DUKE POWER COMPANY

OCONEE NUCLEAR STATION

ATTACHMENT 1

TECHNICAL SPECIFICATIONS

Figure 3.4.3-1 (page 1 of 1)  
RCS Normal Operational Heatup Limitations  
Applicable for the First 33 EFPY - Oconee Nuclear Station Unit 1

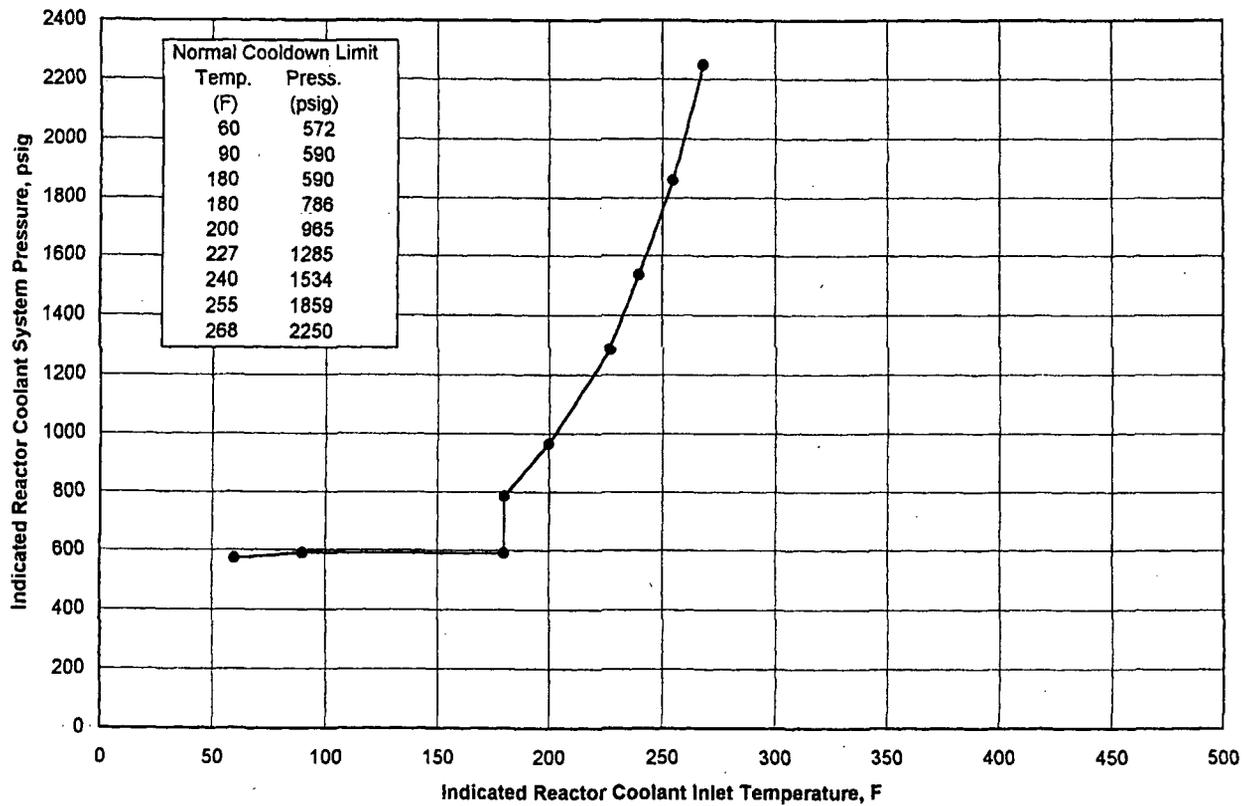
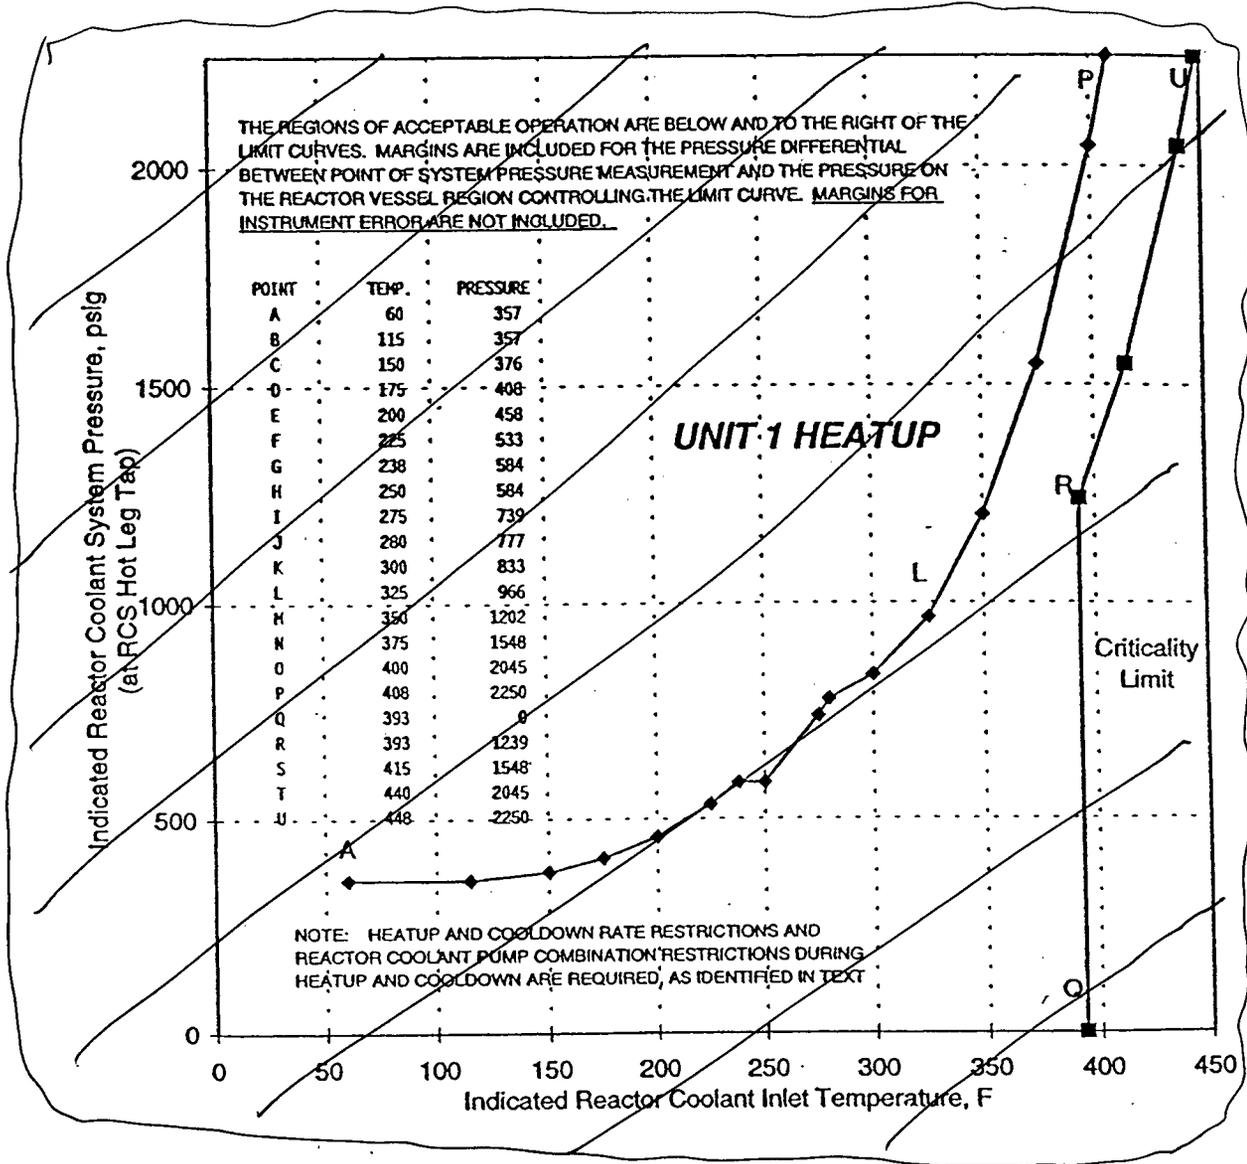
Figure 3.4.3-1 (page 1 of 1)  
RCS Normal Operational Heatup Limitations  
Applicable for the First <sup>(26)</sup> EFPPY - Oconee Nuclear Station Unit 1

33

This proposed amendment revises the pressure-temperature (P-T) limits of Technical Specification (TS) 3.4.1 for Oconee Units 1, 2, and 3. The proposed amendment will revise the heatup, cooldown, and inservice test limitations for the Reactor Coolant System (RCS) of each unit. The service period for the new pressure-temperature limits will be to a maximum of 33 effective full power years (EFPY) for Units 1, 2 and 3.

Figure 3.4.3-2 (page 1 of 1)  
RCS Normal Operational Cooldown Limitations  
Applicable for the First 33 EFPY - Oconee Nuclear Station Unit 1

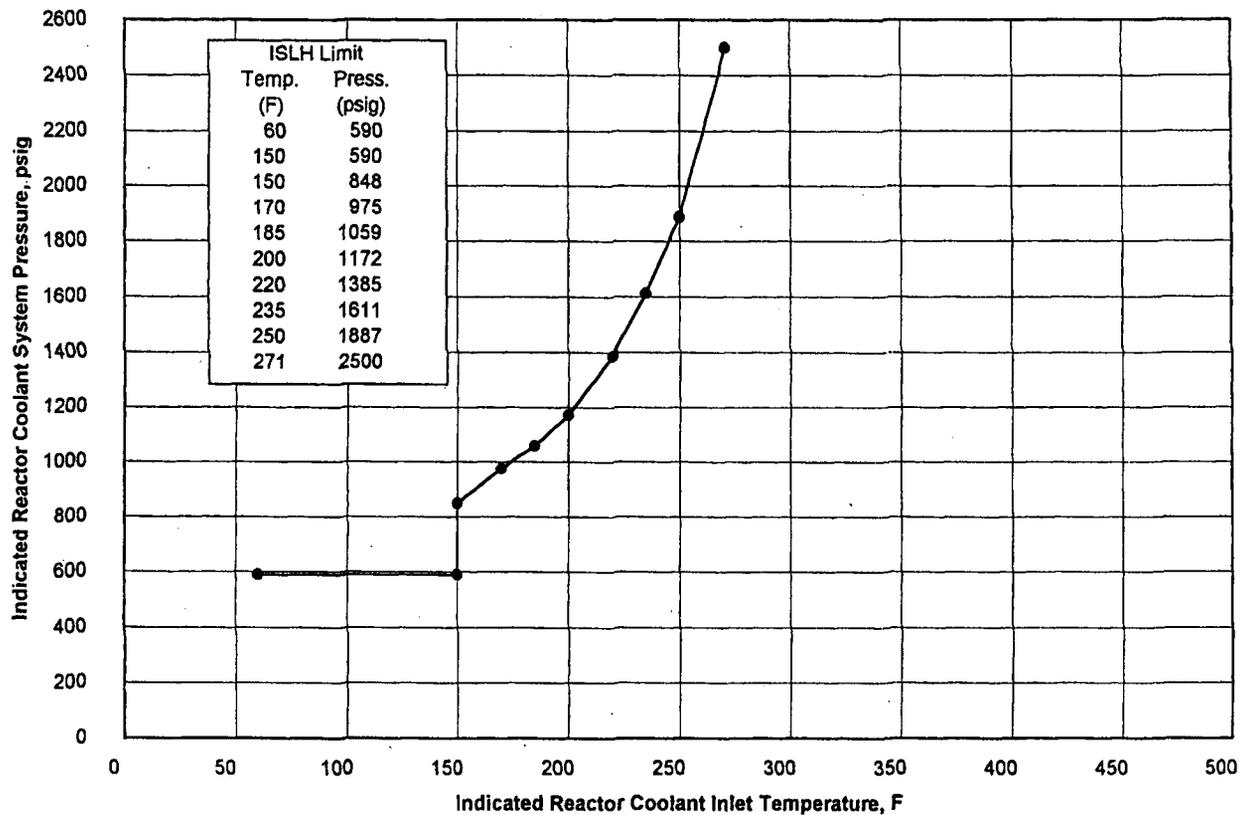
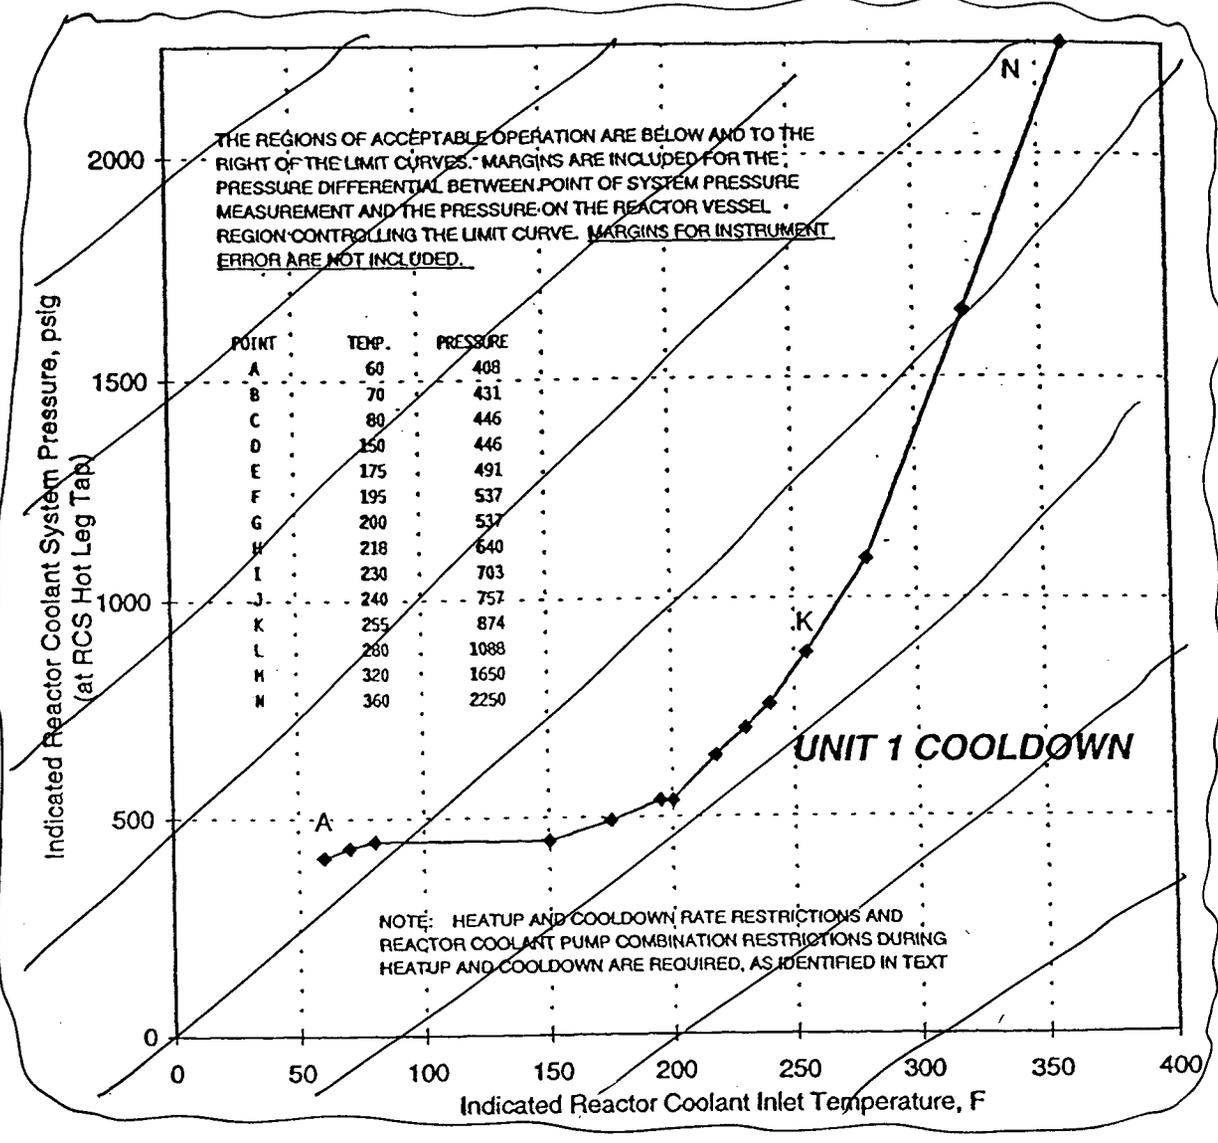
Figure 3.4.3-2 (page 1 of 1)  
RCS Normal Operational Cooldown Limitations  
Applicable for the First 26 EFY - Oconee Nuclear Station Unit 1

26  
33

Figure 3.4.3-3 (page 1 of 1)  
RCS Leak and Hydrostatic Test Heatup and Cooldown Limitations  
Applicable for the First 33 EFPY - Oconee Nuclear Station Unit 1

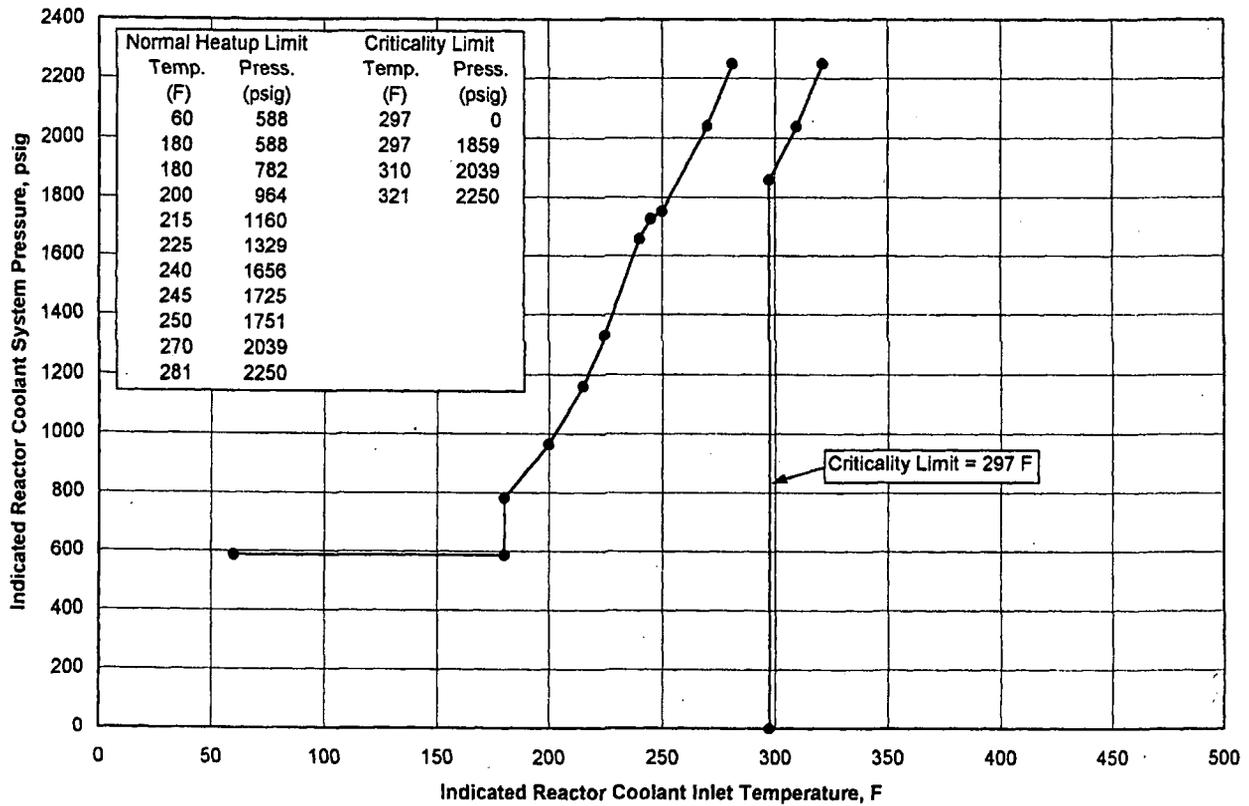
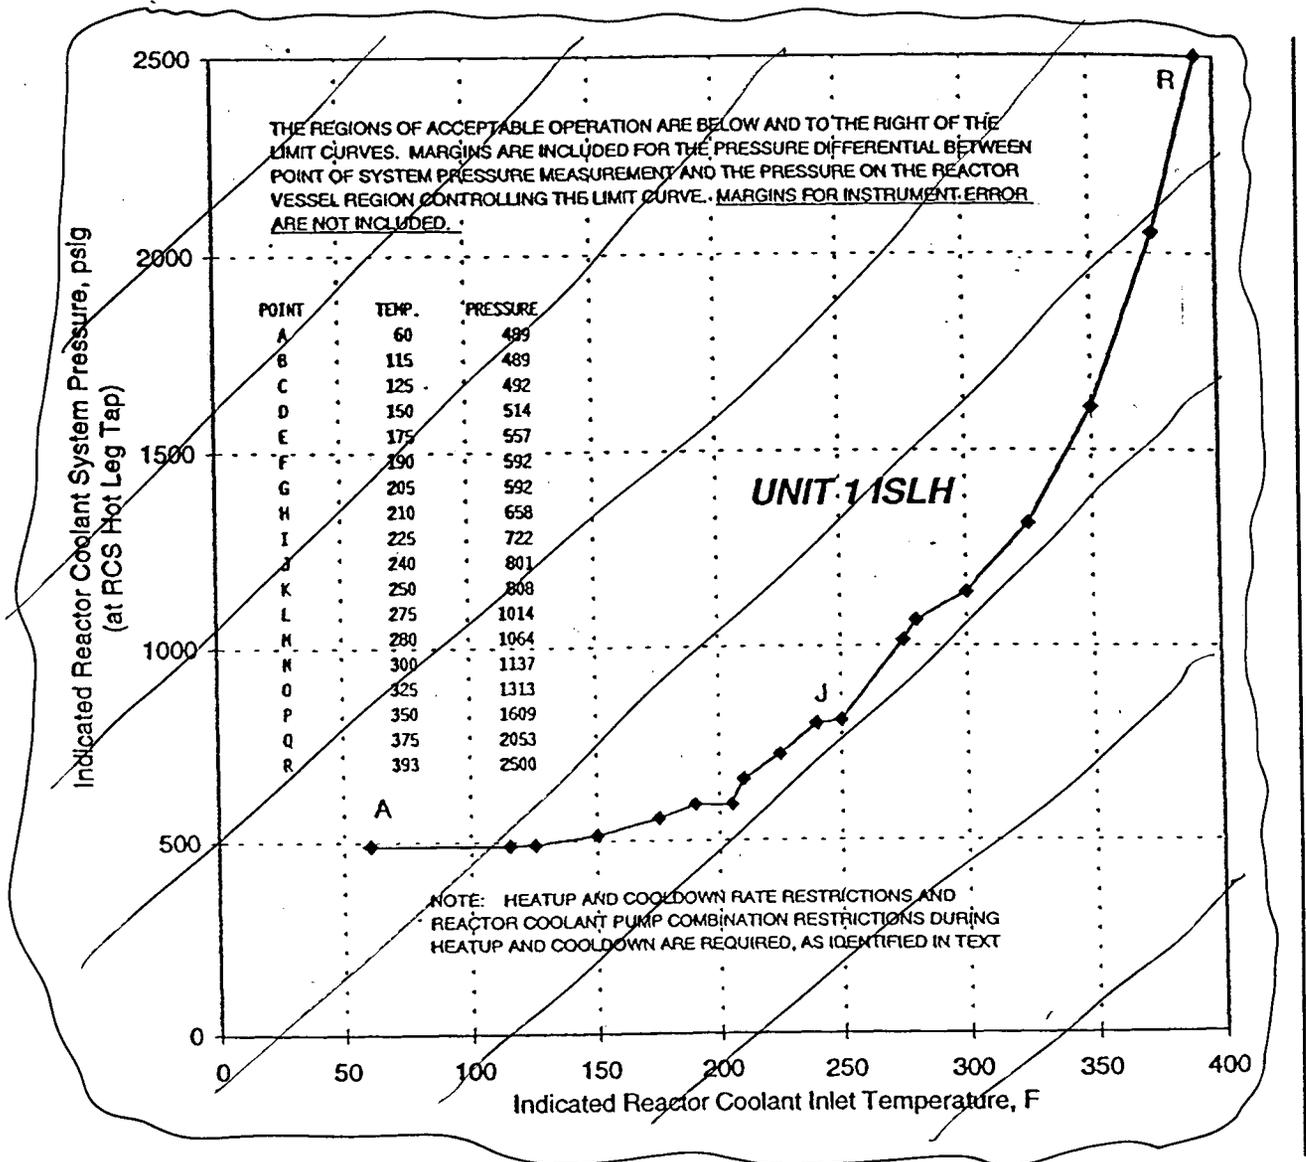
Figure 3.4.3-3 (page 1 of 1)  
RCS Leak and Hydrostatic Test Heatup and Cooldown Limitations  
Applicable for the First 20 EFPY - Oconee Nuclear Station Unit 1

20  
33

Figure 3.4.3-4 (page 1 of 1)  
RCS Normal Operational Heatup Limitations  
Applicable for the First 33 EFPY - Oconee Nuclear Station Unit 2

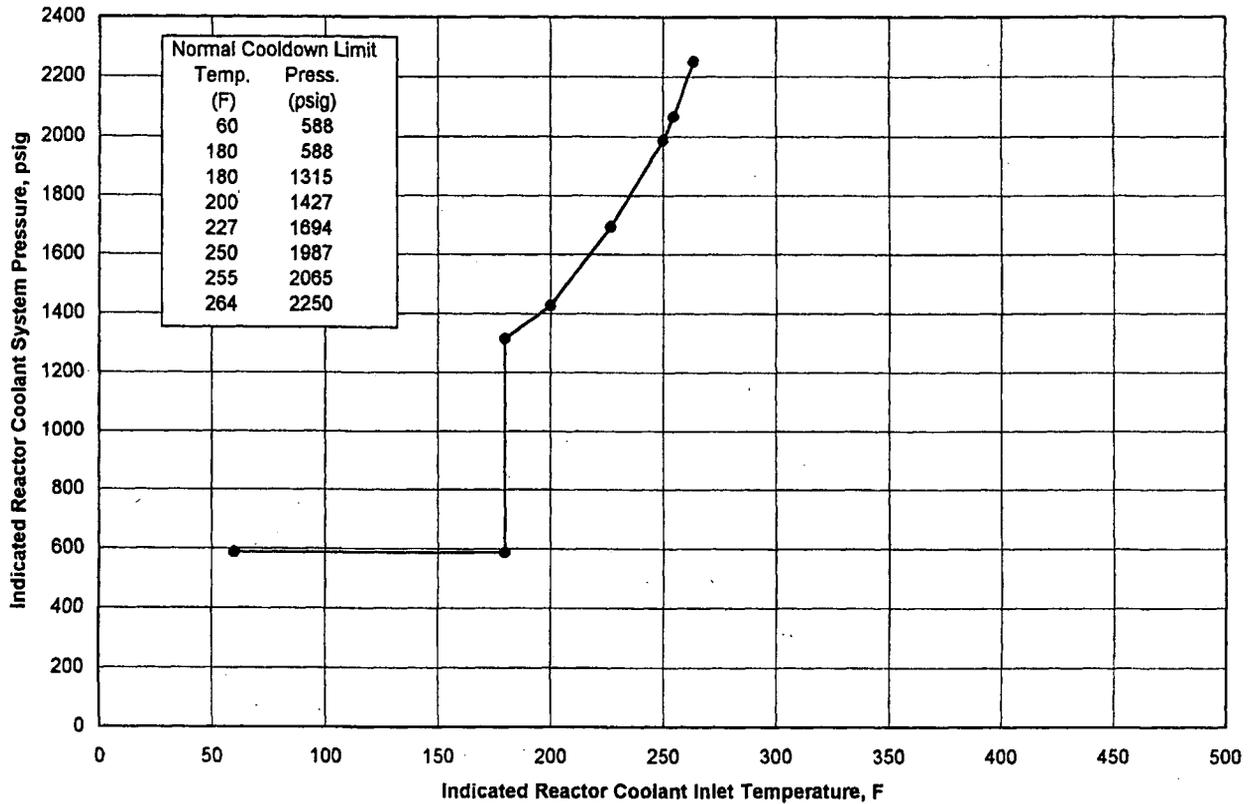
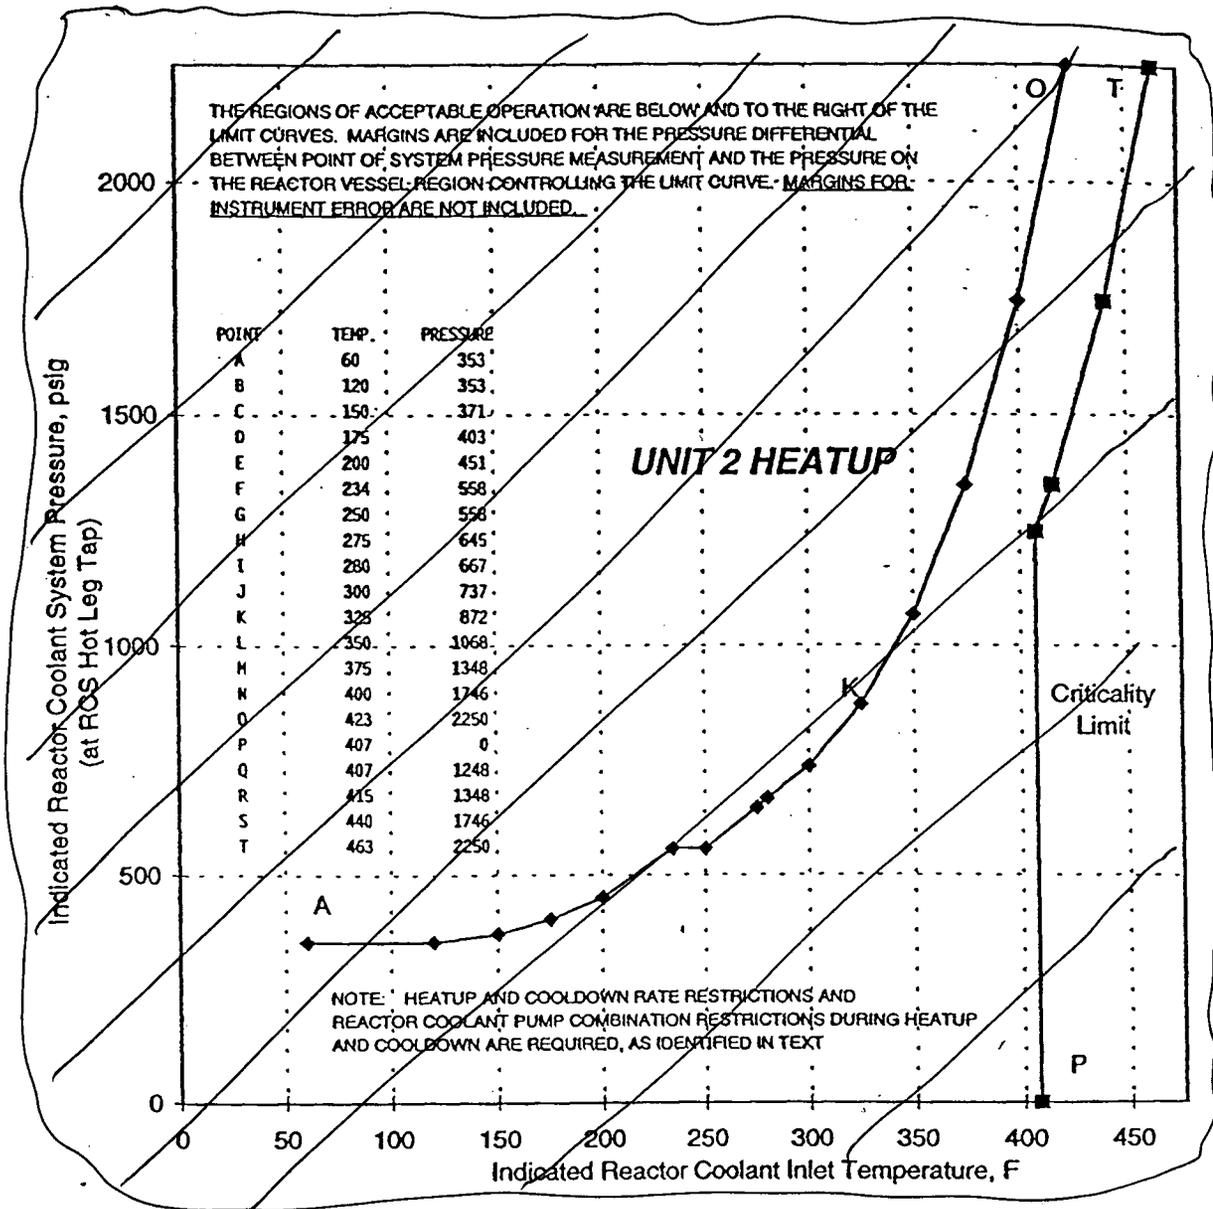
Figure 3.4.3-4 (page 1 of 1)  
RCS Normal Operational Heatup Limitations  
Applicable for the First 26 EFY - Oconee Nuclear Station Unit 2

26  
33
